PROJECT: Bid Pack No. 2 Athletic Complex Renovations, Classroom Addition, Team Room & Site Work

SUBJECT: Addendum No. 1

Addendum No: 1 Project Number: 22-037

Project: Beal City Public School Date: 4/16/25

END OF SECTION 105113

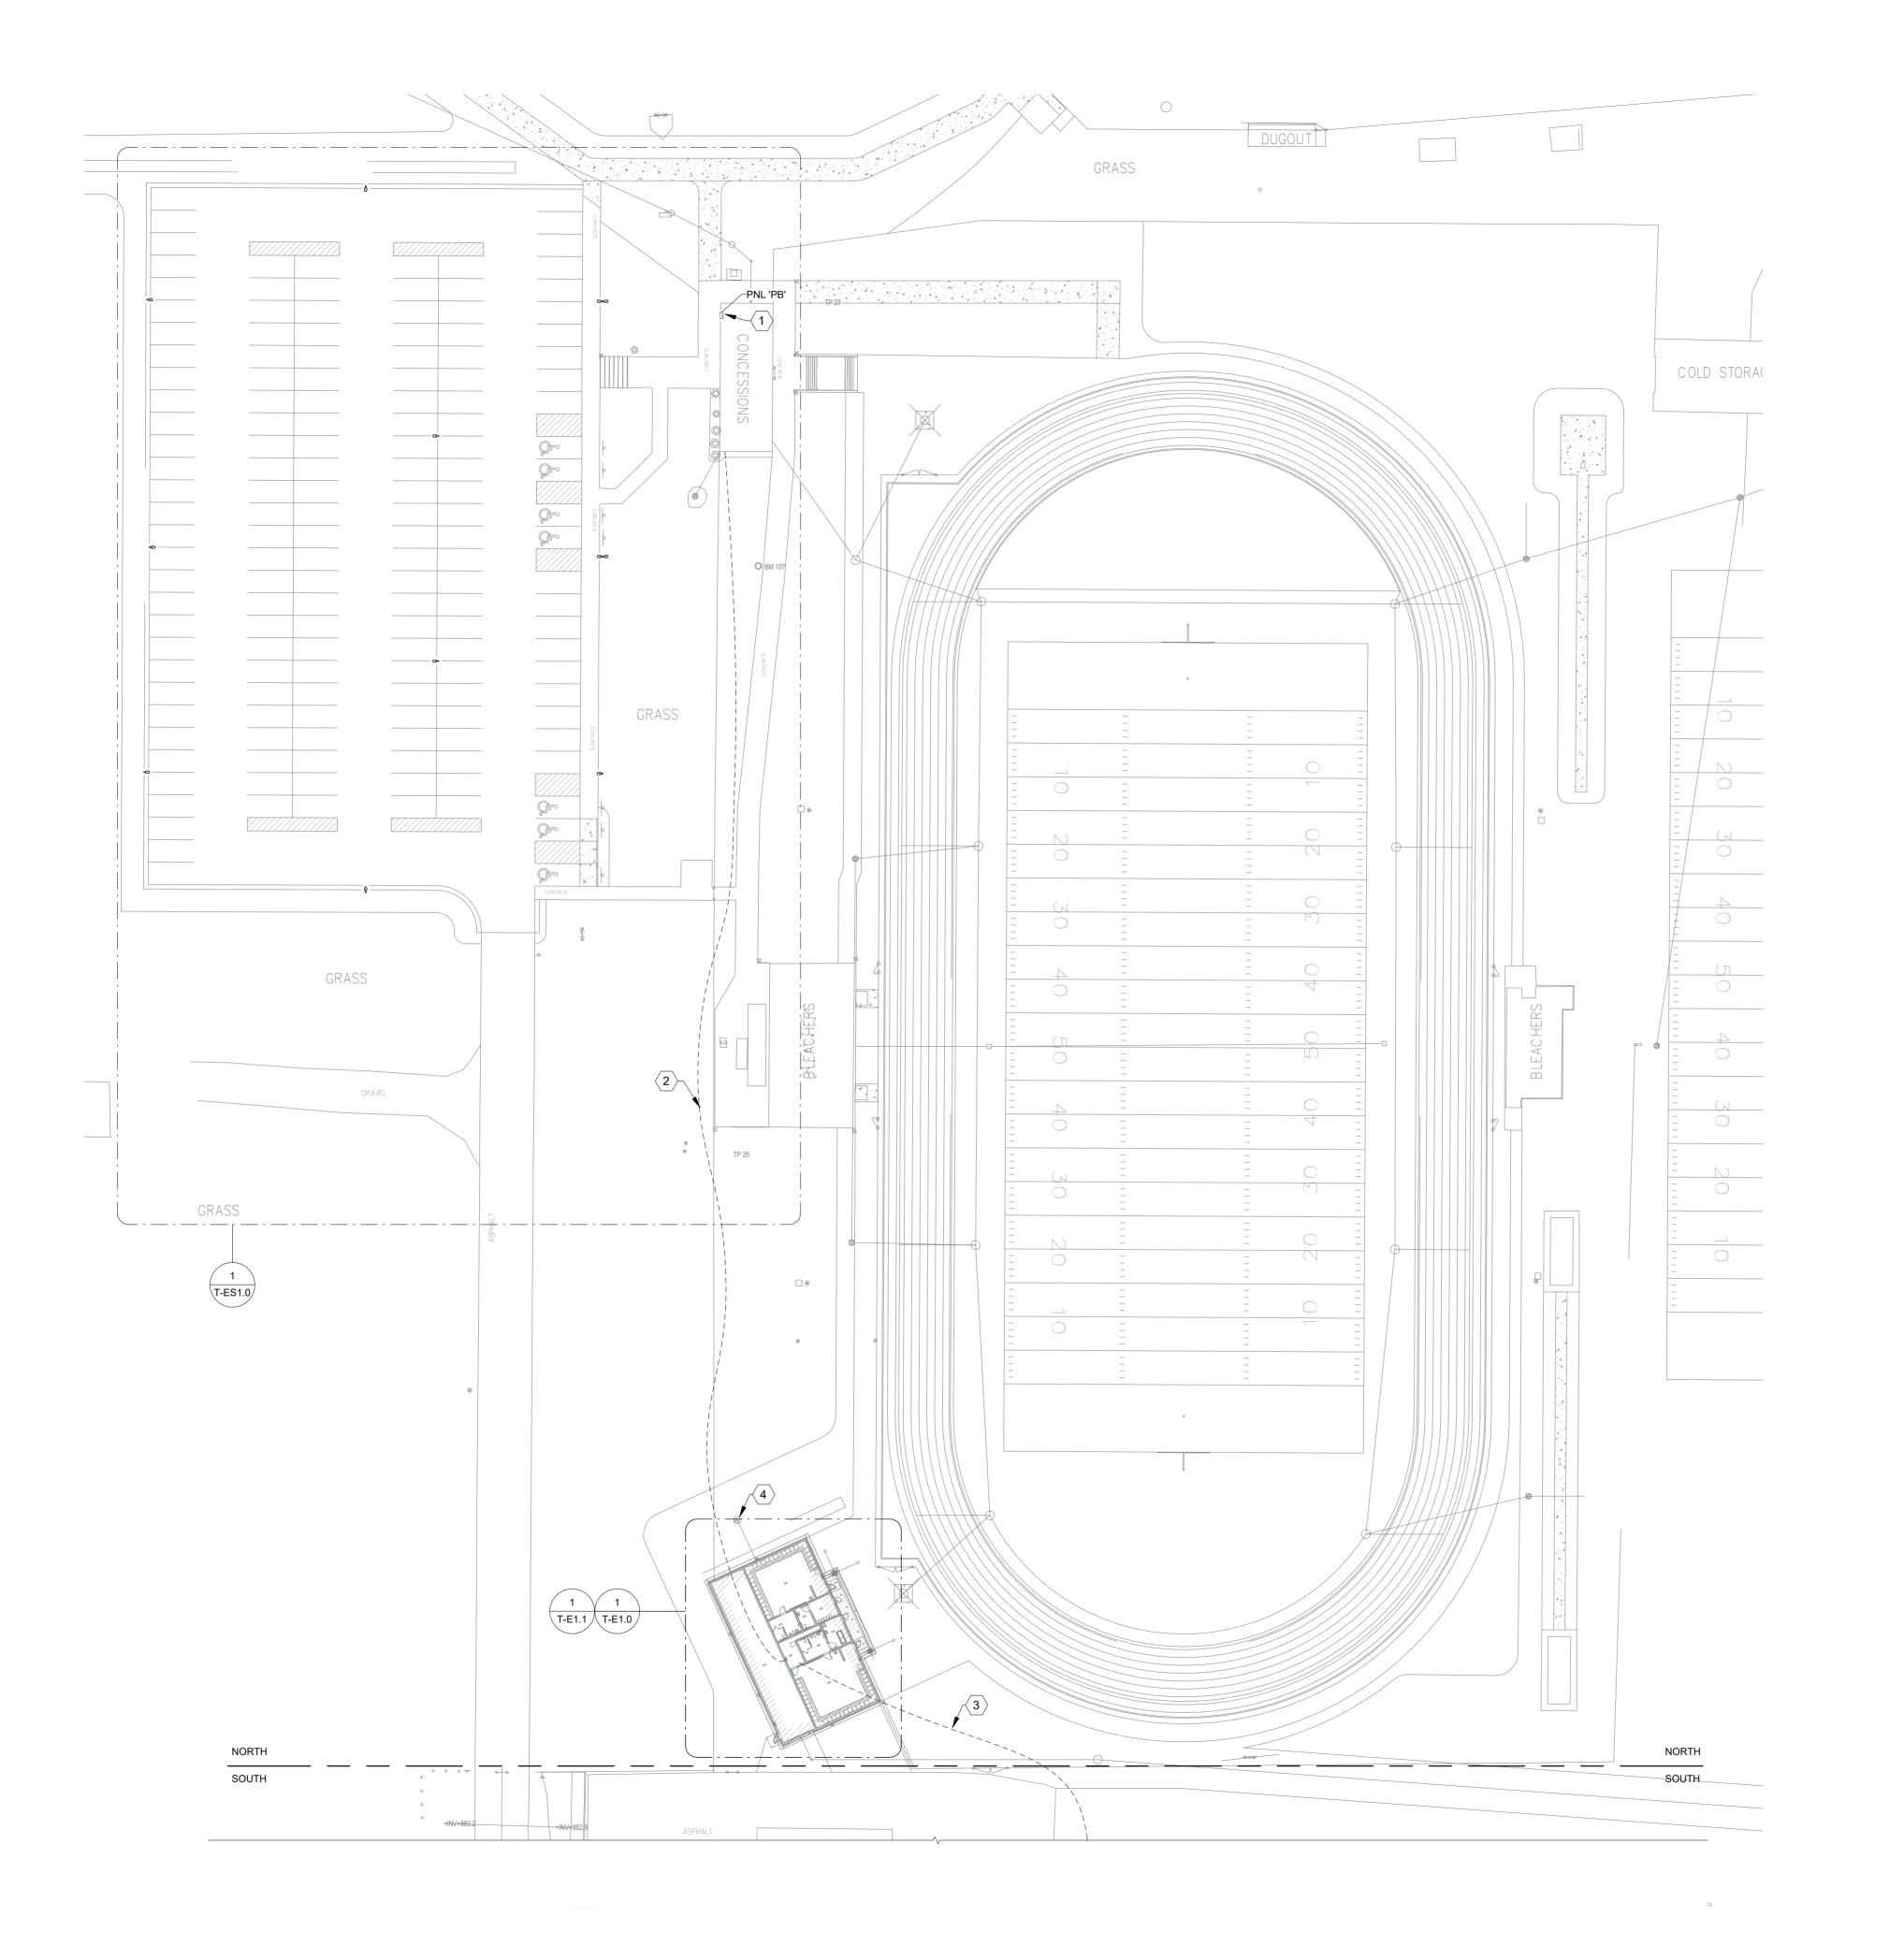
Item 6: RFI #7 – refer to attached specification section for Locker Room Benches.

- A. Manufacturers:
 - 1. Lyon Workspace Products, LLC., basis of design.
 - 2. Penco Products, Inc.
 - 3. Republic Storage Products
- B. Bench Seat shall be laminated selected hardwood, 1-1/4" full finished thickness. All corners are to be rounded and sanded. Surfaces shall be finished with two coats of clear lacquer. Bench tops are to be 24 inches deep and 48 inches wide.

- C. Bench Back shall be laminated selected hardwood, 1-1/4" full finished thickness. All corners are to be rounded and sanded. Surfaces shall be finished with two coats of clear lacquer. Bench back is to be 18 inches high and 48 inches wide. Provide bench back support bracket by manufacturer.
- D. ADA locker bench pedestals shall be fabricated out of 14-gauge steel with 1-5/8-inch tubing uprights. Powder coat paint finish selected from manufacturer standards.
- E. Anchor to floor.

T-E0.1

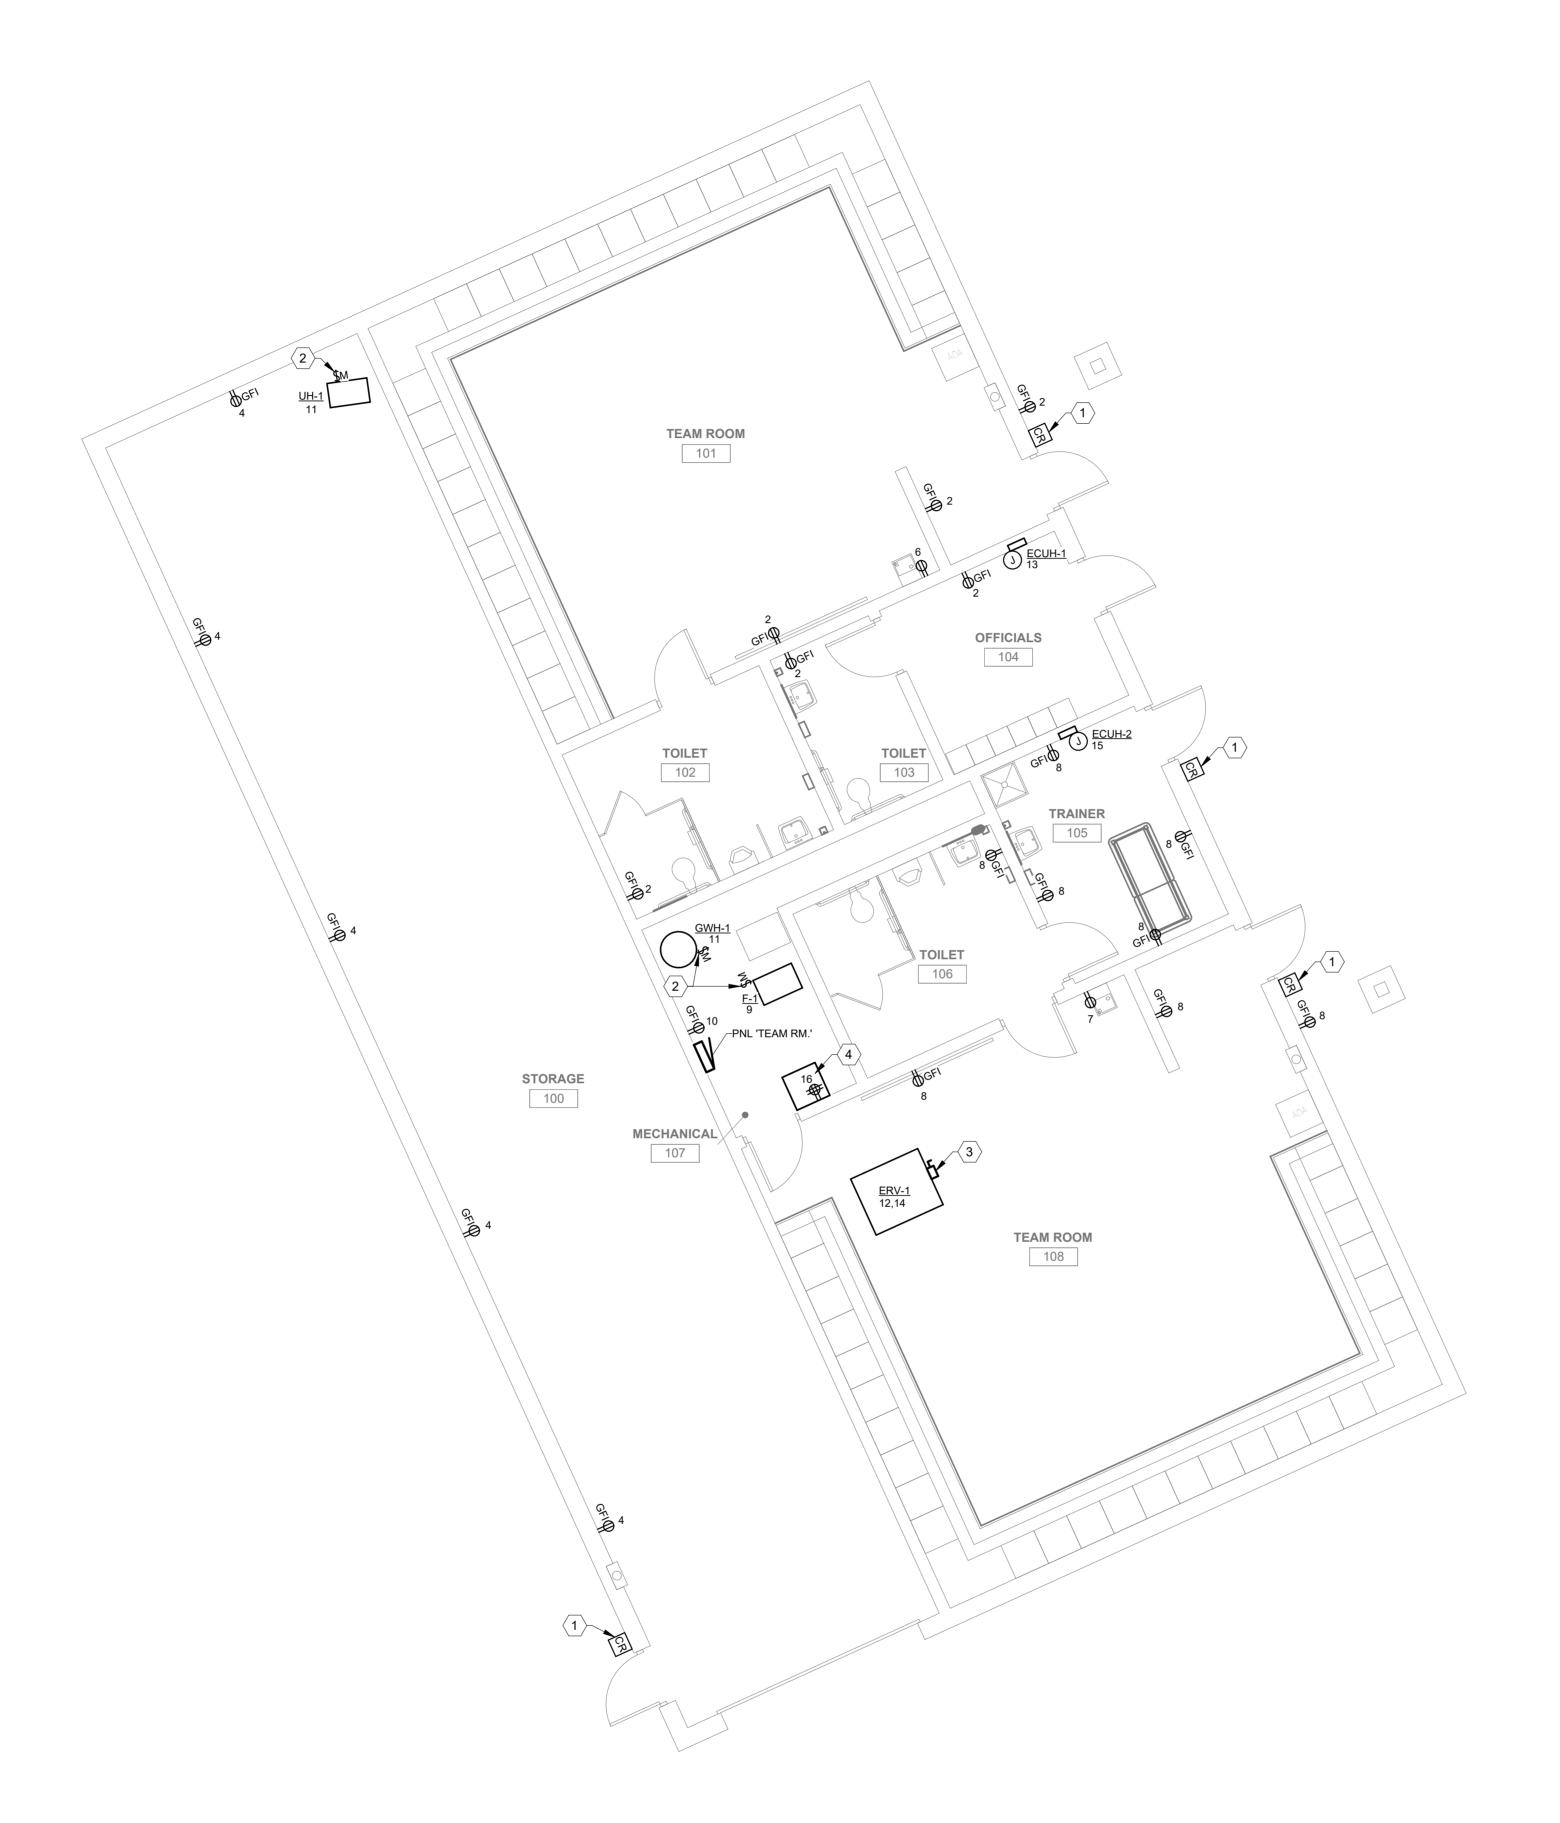
Item 8: Added fiber from school to team room.

CONTINUATION OF CONDUIT AND FIBER FROM SCHOOL. STUB
UP IN MECHANICAL ROOM. SEE SHEET T-E0.2 & T-E1.1 FOR
ADDITIONAL DETAILS.

PROVIDE 2" CONDUIT FROM EXISTING IDF RACK OUT TO NEW TEAM ROOM. PROVIDE 2 STRAND, INDOOR/OUTDOOR RATED SINGLEMODE FIBER. COORDINATE EXACT FIBER SPECIFICATIONS WITH SCHOOL IT PERSONNEL PRIOR TO ORDERING. TERMINATE BOTH ENDS.

T-ES1.0

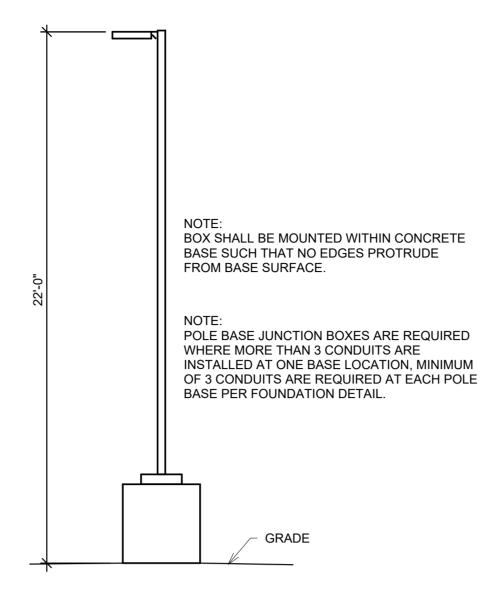
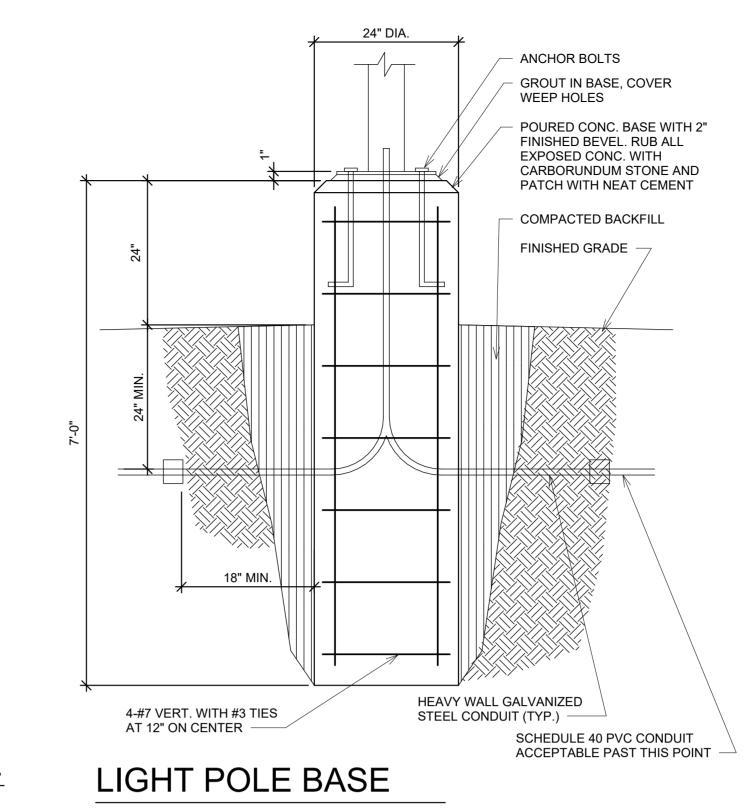
Item 9: Revised parking lot camera locations. Added cabling to new cameras.

INSTALL OWNER PROVIDED CAMERA ON LIGHT POLE. PROVIDE (1) INDOOR/OUTDOOR GAMECHANGER CABLE FROM EXISTING SWITCH TO EACH CAMERA. CAMERA CONDUIT SHALL RUN ALONGSIDE SITE LIGHTING CONDUIT.
